Re: 251334
REUNION AT BLACKWELL/ Bldg D

Job	Truss	Truss Type	Qty	Ply	REUNION AT BLACKWELL/ Bldg D
251334	ASA	Hip	1	1	Job Reference (optional)

REFER TO MITEK REFERENCE NUMBER 178869129 FOR REPAIR DETAIL

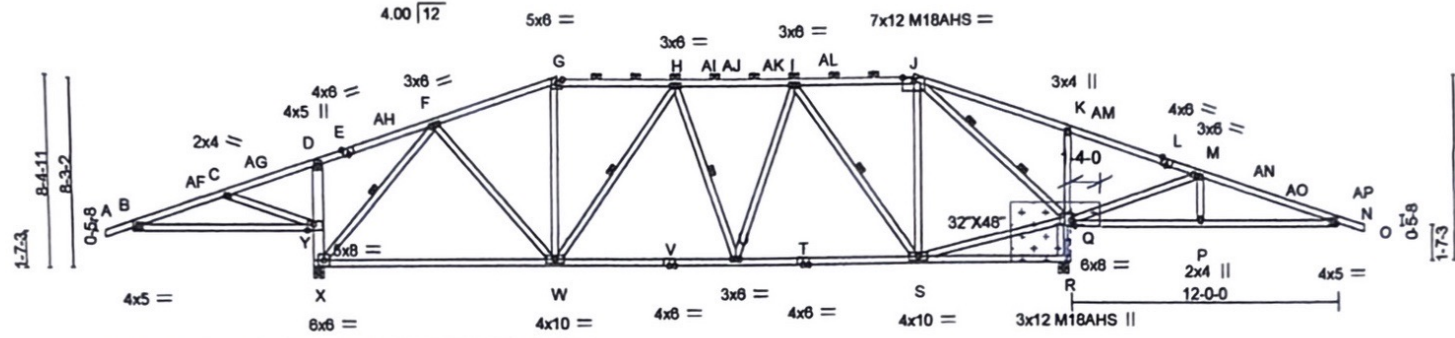
REPAIR.
REMOVE 0-1-8 FROM Q-R

LUMBER AND CONNECTOR PLATES (SHOWN DASHED) TO BE CUT CLEANLY AND ACCURATELY AND THE REMAINING PLATE(S) MUST BE FULLY EMBEDDED AND UNDISTURBED.
6x8 PLATE AT JT. Q MUST REMAIN INTACT WITHOUT DISTURBANCE.

ATTACH 7/16" OSB GUSSET (7/16" RATED SHEATHING 24/16 EXP 1) TO EACH FACE OF TRUSS WITH (0.131" X 2.5" MIN.) NAILS PER THE FOLLOWING NAIL SCHEDULE:
2 X 3'S - 2 ROWS, 2 X 4'S - 3 ROWS, 2 X 6'S AND LARGER - 4 ROWS: SPACED @ 4" O.C.
NAILS TO BE DRIVEN FROM BOTH FACES. STAGGER SPACING FROM FRONT TO BACK FACE FOR A NET 2" O.C. SPACING IN EACH COVERED TRUSS MEMBER. USE 2" MEMBER END DISTANCE.

INSTALL 2 X 4 SPF/DF/SP NO 2; CUT TO FIT TIGHT TRIM CORNER OF NEW MEMBER TO AVOID DAMAGE TO EXISTING CONNECTOR PLATES.

Job	Truss	Truss Type	Qty	Ply	REUNION AT BLACKWELL/ Bldg D	178889131
251334	A7A	Hip	1	1

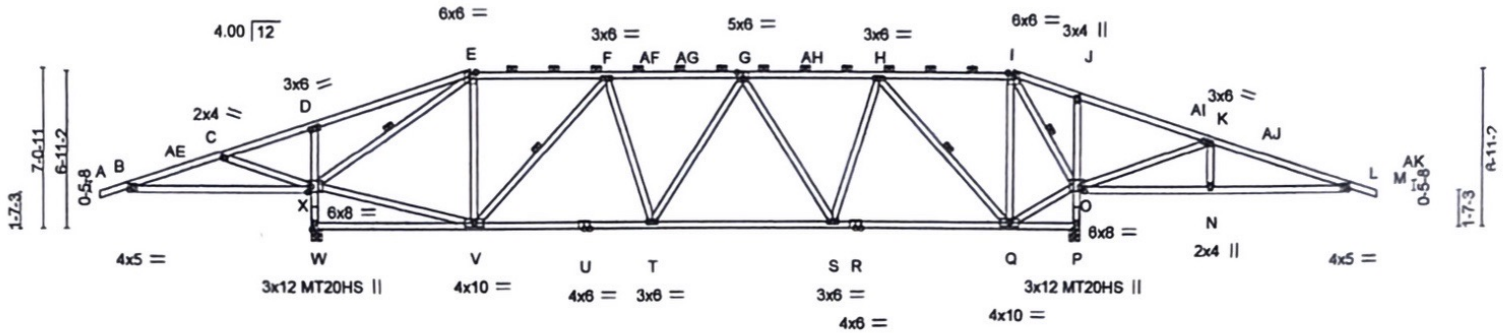
REFER TO MITEK REFERENCE NUMBER I78889129 FOR REPAIR DETAIL

Job	Truss	Truss Type	Qty	Ply	REUNION AT BLACKWELL/ Bldg D	178869132
251334	FL1	Flat Girder	2	2	Job Reference (optional)

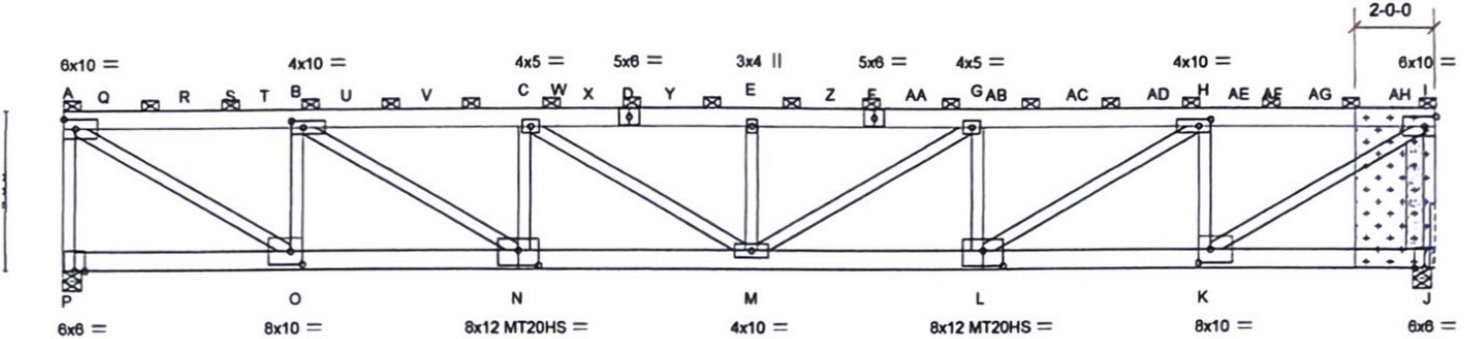
LUMBER AND CONNECTOR PLATES (SHOWN DASHED) TO BE CUT CLEANLY AND ACCURATELY AND THE REMAINING PLATE(S) MUST BE FULLY EMBEDDED AND UNDISTURBED. 6x10 PLATE AT JT. "I" MUST REMAIN INTACT WITHOUT DISTURBANCE.

REPAIR:
REMOVE 0-1-8 BY 1-7-3 SECTION OF RIGHT END VERTICAL STARTING AT JOINT J (ONE-PLY)

ATTACH < 2 LAYERS > 3/4" PLYWOOD OR OSB GUSSET (23/32" RATED SHEATHING 48/24 EXP 1) TO EACH FACE OF TRUSS WITH (0.131" X 3.0") NAILS PER THE FOLLOWING NAIL SCHEDULE. 2 X 4'S - 3 ROWS, 2 X 6'S AND LARGER - 4 ROWS. SPACED @ 2" O.C. USE 2" MEMBER END DISTANCE. GLUE PLYWOOD LAYERS TOGETHER PRIOR TO ATTACHING TO TRUSS.

INSTALL (2 PLY) 2 X 6 SPF/DF/SP NO.2 CUT TO FIT TIGHT. ATTACH PLYS WITH TWO ROWS OF (0.131 X 3") NAILS SPACED 9" O.C. TRIM CORNER OF NEW MEMBER TO AVOID DAMAGE TO EXISTING CONNECTOR PLATES.
